Project Title: La Cuentista Subdivision Unit II Building Permit #: _____ City Drainage #: D10D002

Drainage Report
ADDENDUM 02
for
LA CUENTISTA
SUBDIVISION, UNIT II

Re: La Cuentista Unit II Drainage Report Addendum 02

Addendum 02 to Drainage Report for La Cuentista Subdivision Unit II, January 2007

Table 1 - First Flush Volume Calculation		
Rainfall Depth (in)	Impervious Area (ac)	V _{FF} (ac-ft)
0.34	18.38	0.521

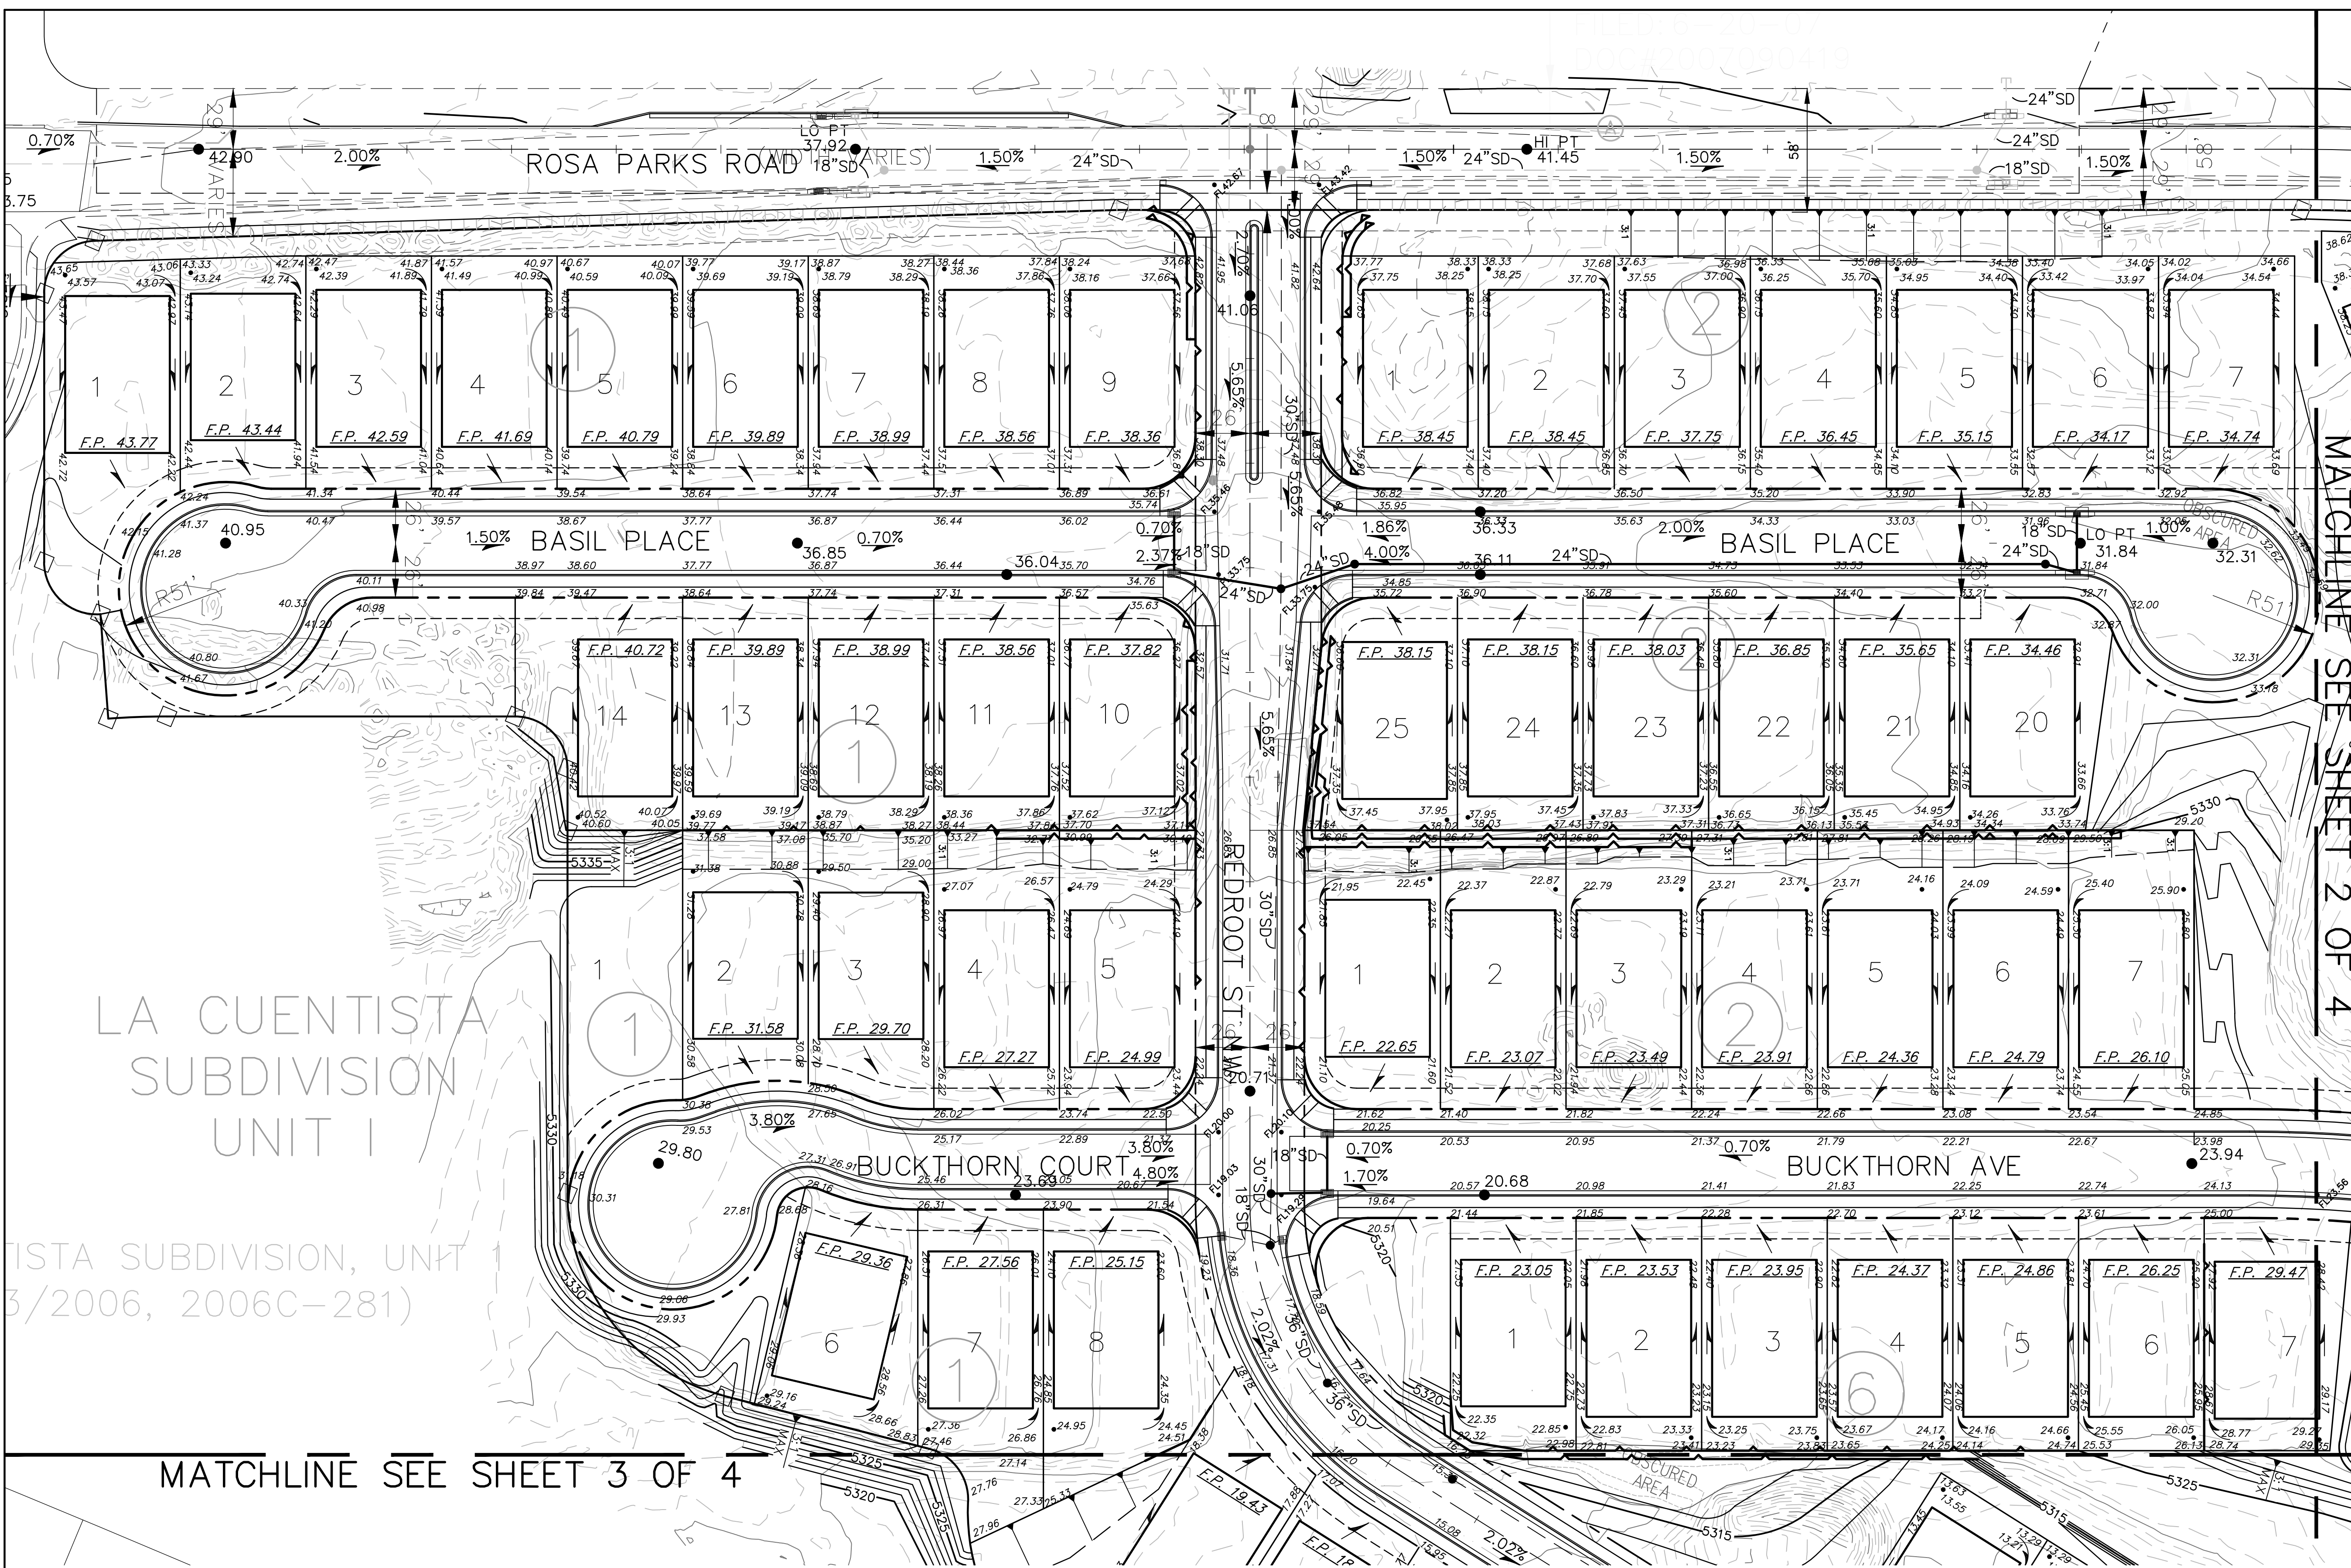
This addendum addresses the first flush calculations for the La Cuentista Subdivision Unit II. The existing pond in Unit II is a detention pond which requires some modifications to retain the first flush volume.

The site drains into the existing detention pond. The existing pond will be re-graded below the outlet invert elevation to retain the first flush volume in the existing pond. The site is about 34.5 acres and includes 18.4 acres of impervious land treatment. See Table 1 – First Flush Volume Calculation.

This addendum addresses the addition of retention volume to store the first flush. The pond will be graded below the invert elevation of the pond outlet to retain the required volume.

The retention volume provided is 0.592 ac-ft. See Grading and Drainage Plan for details.
